**REGULAR MEETING OF THE
TOWN OF VICTOR CONSERVATION BOARD
November 6, 2018**

2. TORPEY SUBDIVISION

3. CZARNECKI, CRIS/JILL – POOL, PATIO, DECK

4. STRONG/PARISH ROAD SUBDIVISION, LOT 1 3-MS-18

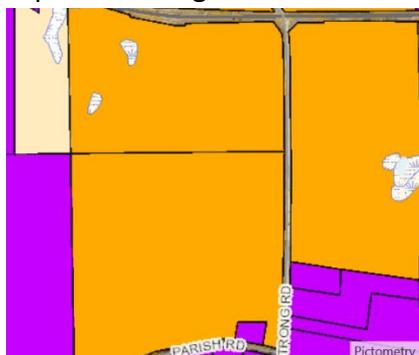
The soils on site are Arkport Sandy Loam with no concern about depth to water table (201 cm). However, the soils are highly erodible; the applicant should carefully plan the time of year that the construction is done to stay out of wet weather where soils could easily erode.

The applicant has picked the appropriate location on the property to cite the pool & deck. It is the only area on the site other than in front of the house that is conducive to the proposed construction.
